DATE: 18 October 95 TIME: 11:25  
FROM: Michelle King PAGES (including cover sheet): 15  
PROJECT: Embassy Inn PROJECT #: 940018-03

MESSAGE: Changes to Risk Management Plan pursuant to  
our meeting on Friday, Oct 13  
Please call with any comments. Thanks!  
Michelle

Risk Management Plan  
for the 64th and 65th Street Properties  
Emeryville, California

Sybase, Inc., Emeryville, California  
(EKI 940018.03)

Proposed Locations of Perimeter Monitoring Wells

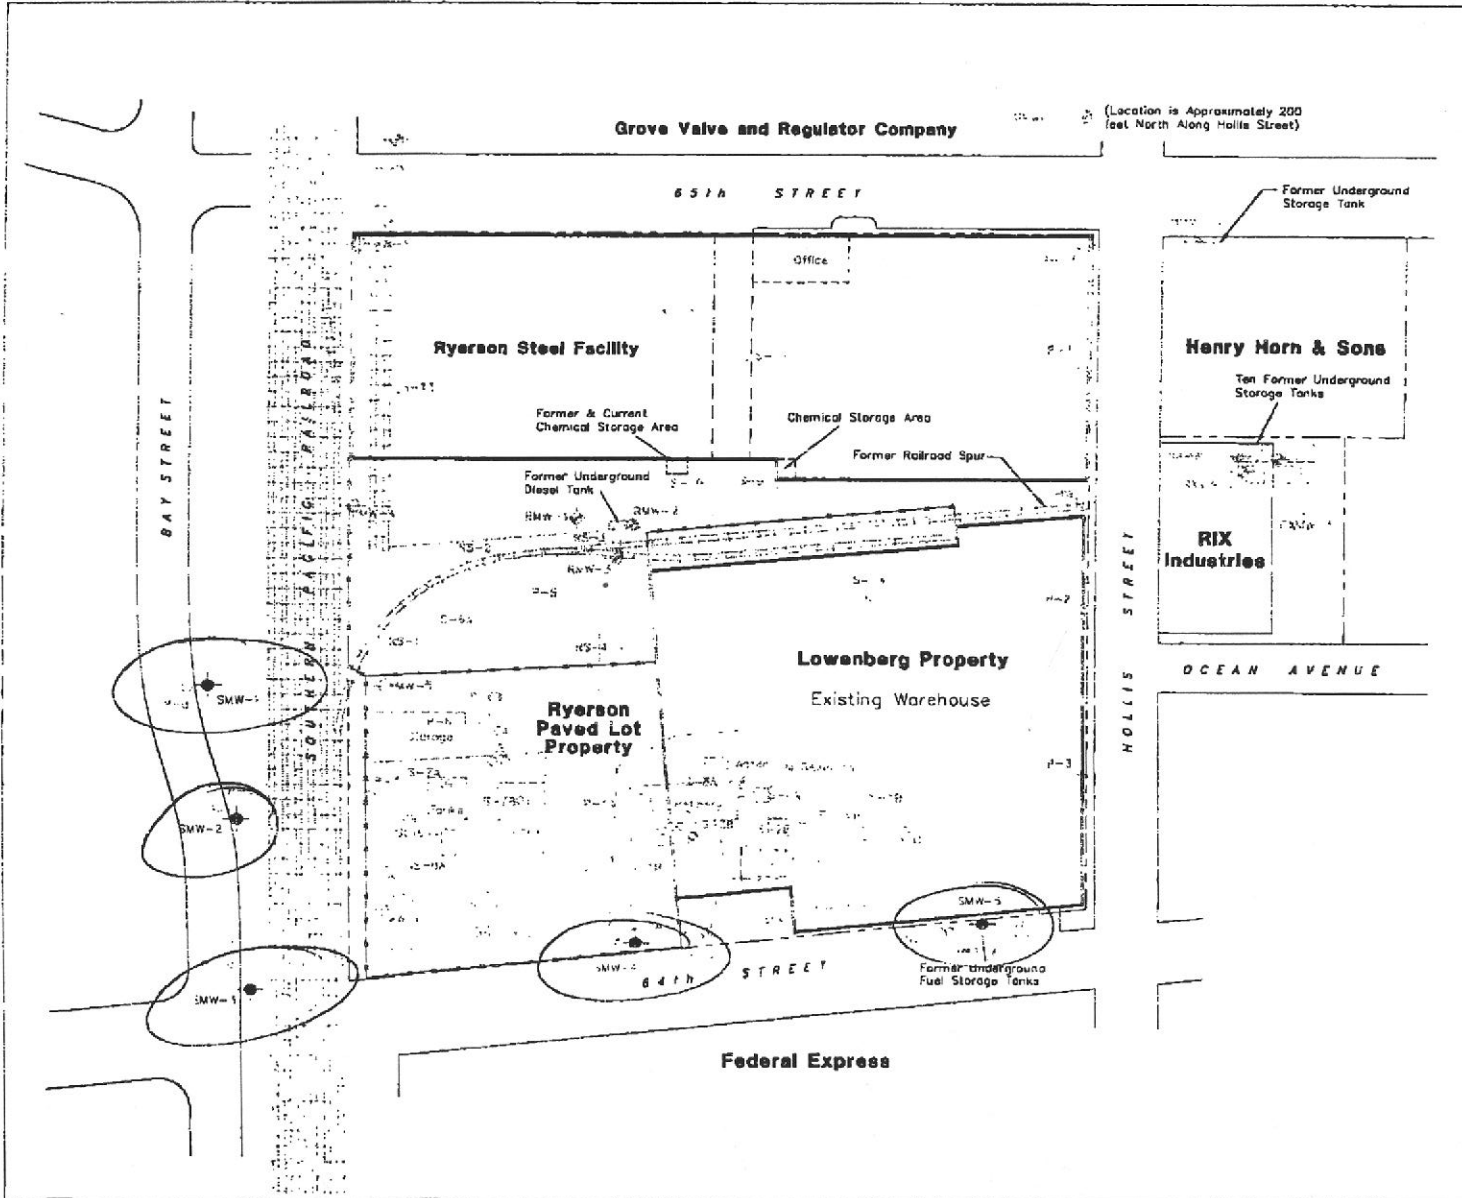
After the Site is redeveloped, four wells proposed for the perimeter groundwater monitoring program (Figure 10) will be constructed, subject to the receipt of necessary permits or approvals. Monitoring wells SMW-1, SMW-2, and SMW-3 will be located in the sidewalk along Bay Street. Well SMW-4 will be located inside the property boundary between the U-shaped office building and parking structure. As discussed above, a fifth well, SMW-5, may be installed in the vicinity of the former Lowenberg tanks. \*

Proposed wells SMW-1 through SMW-3 are located downgradient and off-site (i.e., outside of the area with hydrocarbon concentrations suggestive of residual free phase hydrocarbons). Well SMW-4 is located downgradient of sampling location P-4, in the vicinity of the former refinery. The likely presence of residual free phase hydrocarbons in well SMW-4 might give rise to significant variation in the groundwater chemical analytical results. Well SMW-5 will be located near the former Lowenberg tanks, in the area where groundwater samples have contained elevated levels of benzene, if the tank site has not been closed prior to Sybase, Inc.'s redevelopment of the Site. }

1. All locations are approximate.
2. Basemap taken from Sanborn maps dated 1911 and 1967.
3. Well SMW-3 will be installed only if the Lowenberg tank site has not been closed prior to development of the Lowenberg Property by Sybase, Inc.
